PRODUCT/PROCESS CHANGE NOTICE (PCN)

PCN #: **TB1503-01** DATE: **July 22, 2015**
 Product Affected: **TSSOP-20, TSSOP-24, TSSOP-28,**
 TSSOP-48, TSSOP-56, TVSOP-48
 SOIC-28, SSOP-20, SSOP-28,
 (Refer to Attachment II for affected part# shipped in Reel)
 Date Effective: **November 2, 2015 Earliest Date - Refer to**
 specific date by package type

ATTACHMENT I - PCN #: TB1503-01

Detail of Change: This notification is to advise our customers that IDT has planned to standardize the carrier tape on the selective package types to only one type as detailed below.

Illustration of Carrier Tape Pocket Design Change

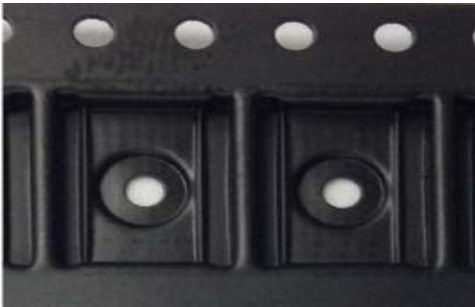
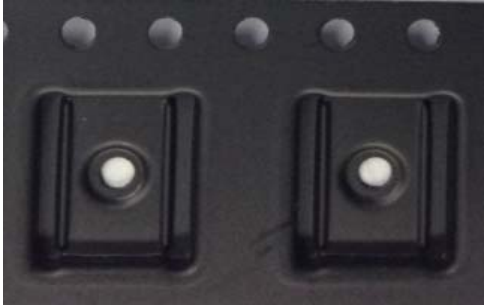
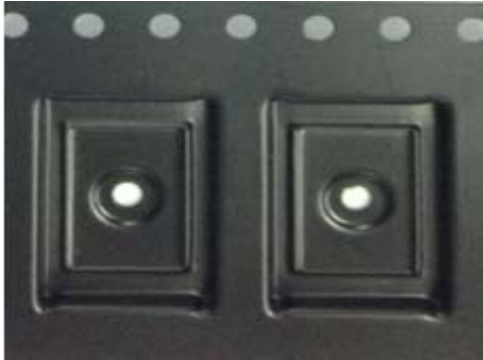
Package	From	To
TSSOP-20	Carrier Tape Part# P8-464-000 	Carrier Tape Part# P8-291-P20 
TSSOP-24	Carrier Tape Part# P8-329-P24 	Carrier Tape Part# P8-169-P24 
TSSOP-48	Carrier Tape Part# P8-260-P48 	Carrier Tape Part# P8-324-P48

Illustration of Carrier Tape Pocket Design Change

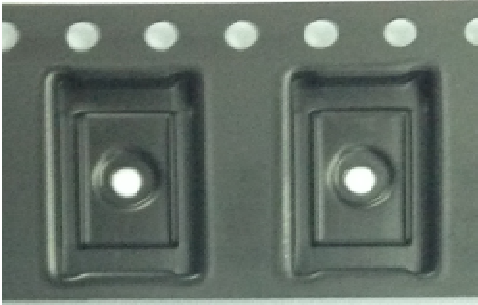
Package	From	To
SOIC-28	Carrier Tape Part# P8-187-S28 	Carrier Tape Part# P8-370-P28 
TSSOP-28 and TVSOP-48	Carrier Tape Part# P8-145-PF8 	Carrier Tape Part# P8-330-P48 
TSSOP-56	Carrier Tape Part# P8-261-P56 	Carrier Tape Part# P8-314-P56

Illustration of Carrier Tape Pocket Design Change

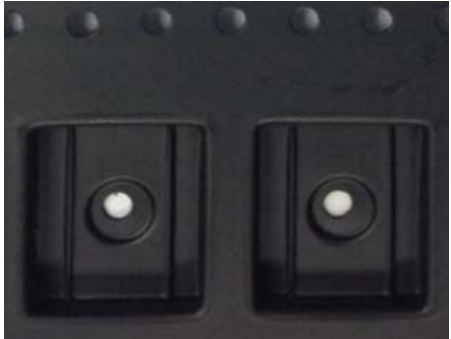
Package	From	To
SSOP-20	Carrier Tape Part# P8-259-P20 	Carrier Tape Part# P8-320-P20 
SSOP-28	Carrier Tape Part# P8-384-P28 	Carrier Tape Part# P8-321-P28
